PCM Service Update

Coast Guard Safety Recall

8.1L Wiring Harness Modification

Engines Affected:	8.1L	Serial Numbers Affected:	2001	415153-415308
	8.1L H.O.		2002	425019-425407
			2003	435002-435003

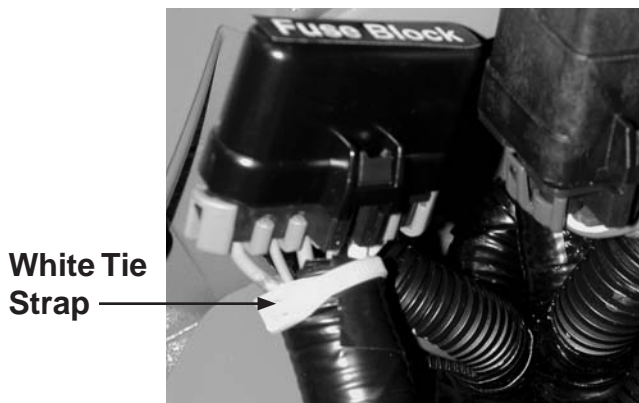
Coast Guard Safety Recall #020174S addresses a possible safety issue with the 8.1L and 8.1L HO engine wiring harness. The condition associated with this recall is the possible melting of the wiring harness. **Engines equipped with a Balmar 100 amp alternator are not effected.**

- A - Charging Circuit Modification**
(Coast Guard Safety Recall #020174S)
 - 6 Gauge Fused Wire From Starter Solenoid to Circuit Breaker/6 Gauge Wire From Circuit Breaker to Alternator B+
 - Ground Wire From Alternator to Bellhousing Starboard Side Ground Stud
(Excluding engines with Balmar 100 amp alternators)

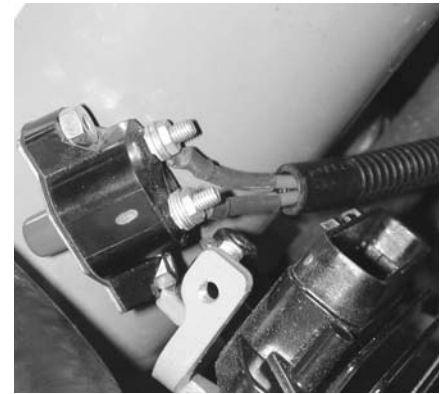
5. Remove the two attaching nuts/washers on the back of the circuit breaker. Remove the ORANGE 12 gauge wire and attach it on the same terminal as the RED/WHITE 10 gauge wire. Install the nut/washer and tighten securely.

6. Attach the two RED 6 gauge wires (supplied in kit) to the other terminal. Install the nut/washer and tighten securely. The circuit breaker should now have one ORANGE and one RED/WHITE wire on one terminal, and the two RED 6 gauge wires on the other terminal. Install the circuit breaker onto the bracket and tighten the screws securely.

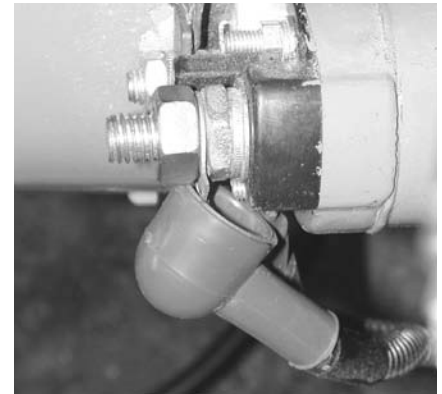
7. Remove the nut and lockwasher from the starter solenoid B+ terminal. Remove the ORANGE wire. Cut the ORANGE wire as far back in the harness as possible. Using electrical tape, tape the end of the wire to prevent any possible shorting to ground, or another circuit.

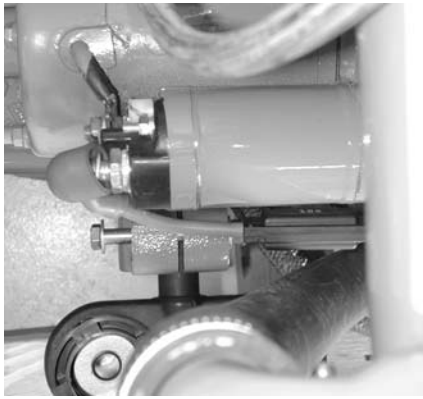
8. Route the fused RED 6 gauge wire from the circuit breaker to the starter solenoid B+ terminal. Install the nut and lockwasher and tighten securely.

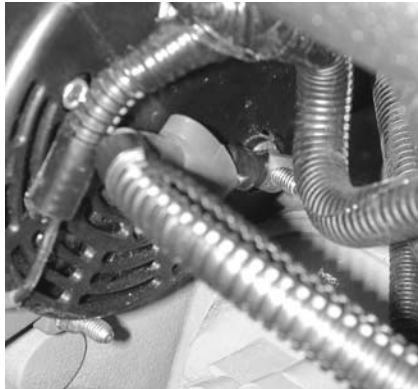
9. Using a 10 mm wrench, remove the ORANGE wire on the back of the alternator. Cut the ORANGE wire as far back in the harness as possible. Using electrical tape, tape the end of the wire to prevent any possible shorting to ground, or another circuit.

10. Route the long RED 6 gauge wire from the circuit breaker to the back of the alternator. Install the nut and lockwasher and tighten securely.

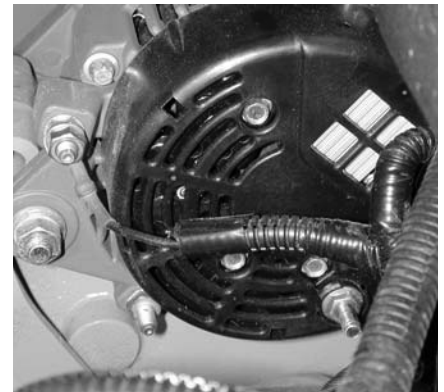
11. Using a 10 mm wrench, remove the BLACK wire on the back of the alternator. Cut the BLACK wire as far back in the harness as possible. Using electrical tape, tape the end of the wire to prevent any possible shorting to another circuit.

12. Attach the 6 gauge BLACK wire, provided in kit, to the back of the alternator ground stud. Route the wire in order to attach the other end to the bellhousing ground stud (ground stud located on the starter side of engine). Tighten securely.

Alternator/Wiring Harness Modification (Bag C)

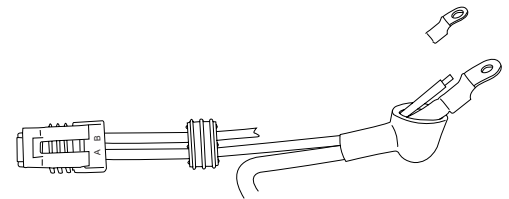
1. Remove the negative side battery terminal.
2. Disconnect the 2-terminal connector from back of the alternator.
3. Verify the PURPLE/WHITE wire is in terminal "B."

4. If the PURPLE/WHITE wire is in terminal "B," proceed with step (5). If not, contact technical assistance at 803-345-0050.
5. Using a small screwdriver, or pick, carefully slide the rubber seal back out of the connector body.

6. Remove the black plastic plug from cavity "A" and discard.
7. Take the red wire, provided in kit, and insert the unterminated end through the front of the connector into cavity "A." Make sure that the terminal is entering the connector in the correct orientation. The terminal will only go in one way, DO NOT force it. Pull the wire until the terminal locks into the connector. If locked correctly, you will not be able to push the wire and terminal back out.

Crankshaft Position Sensor Replacement (Bag D)

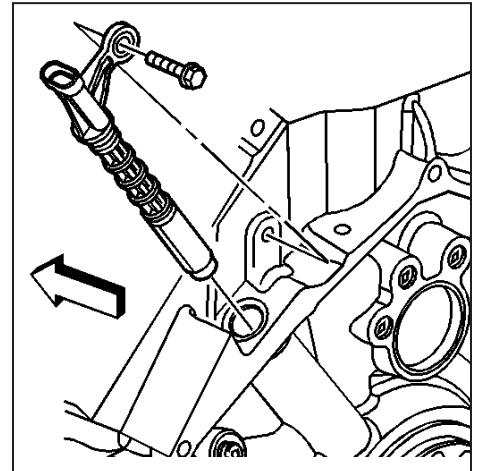
2. Remove the crankshaft position sensor bolt.
3. Apply penetrating oil to the crankshaft position sensor-to-engine block mating surface. Allow the penetrating oil to soak for several minutes, to help loosen the O-ring from the engine block.
4. Remove the crankshaft position sensor.

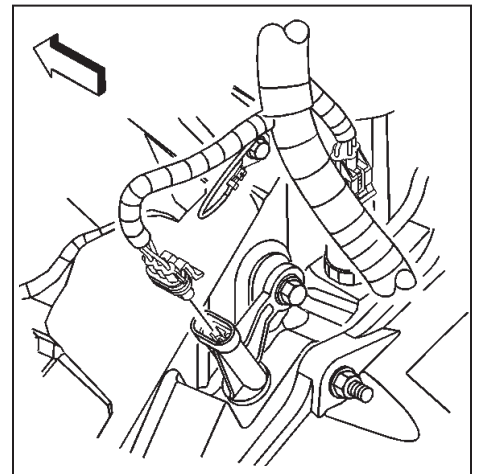
5. Install the crankshaft position sensor into the engine block. There may be a slight resistance as the O-ring seats into the engine block.
6. Apply thread sealer GM P/N 12345493 or equivalent to the crankshaft position sensor bolt.
7. Install the crankshaft position sensor bolt.

Tighten the crankshaft position sensor bolt to 12 N·m (106 lb in).
